# Groundwater Transfer Review Summary Form

Transfer/PA # T- 14806

GW Reviewer Grayson Fish Date Review Completed: 2/9/2026

Application: T-14806

# Observation Well Data

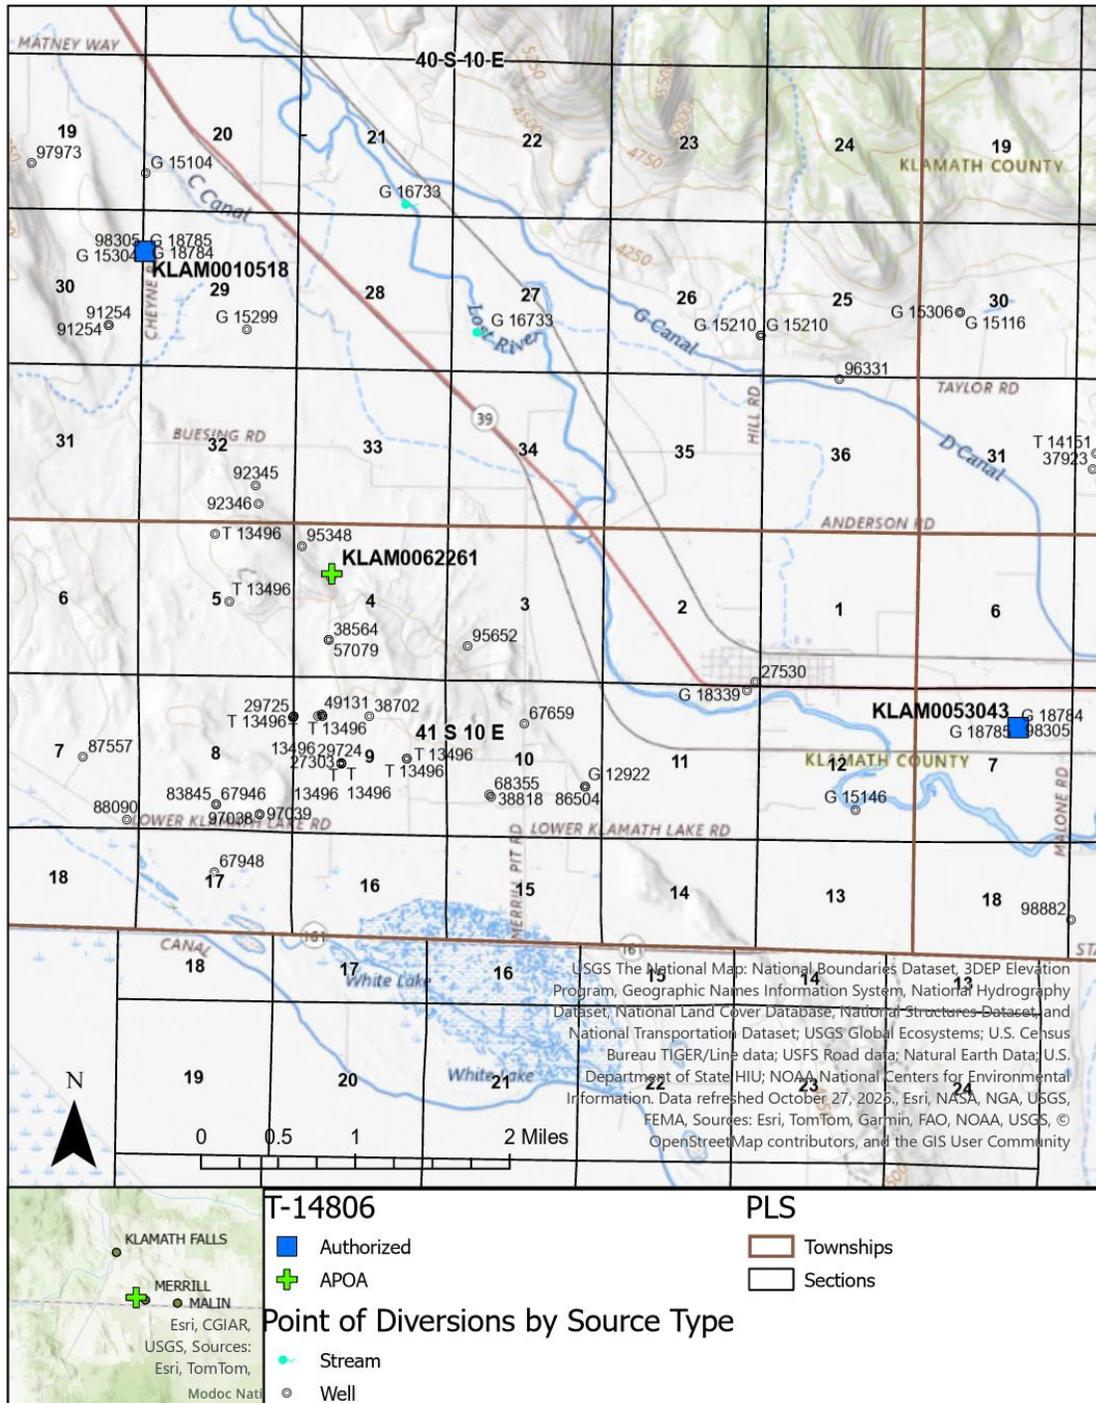
Recent spring groundwater level measurements in both authorized POAs do not exceed the permit decline condition. However, both POAs showed greater than 25 feet of decline when compared to the established reference levels in spring 2022 and spring 2023 (see attached hydrograph). A recommended provisional reference level for proposed Well 3 is discussed in Section 9.

9. Any additional comments: As noted in Section 3 of this review form, Certificate 98305 is subject to water level decline conditions and both authorized wells listed under this certificate triggered the 25 feet of total decline condition in Spring 2022 and Spring 2023. The only static water level available for the proposed APOA Well 3 (KLAM 62261) is 144 feet below land surface (bls) and was collected 8/16/2025. The elevation of the water level in KLAM 62261 is within ~1 foot of the elevation of the water level collected from Well 2 (KLAM 10518) on 7/28/2025 (see attached hydrograph).

The similar groundwater elevations measured during July and August 2025 in both Well 2 and the proposed Well 3, along with the knowledge that other wells in the area sourcing water from the highly transmissive volcanic aquifer show similar groundwater elevations, suggest that Well 2 and Well 3 are likely to show similar groundwater elevations in the future. Additionally, the aquifer has likely experienced similar declines at the location of Proposed Well 3 as it has at the location of Well 2.

It is recommended that a provisional reference level be applied to proposed Well 3 (KLAM 62261) that matches the elevation of the reference level listed in Certificate 98305 for Well 2 (KLAM 10518). The recommended reference level is provisional as only a single water level measurement is available from KLAM 62261. If additional groundwater levels collected from KLAM 62261 show substantially different groundwater elevations than those measured in KLAM 10518, the provisional reference level recommended in this review may need to be re-evaluated.

**130.32 ft bls** is the recommended provisional reference level for Proposed Well 3.
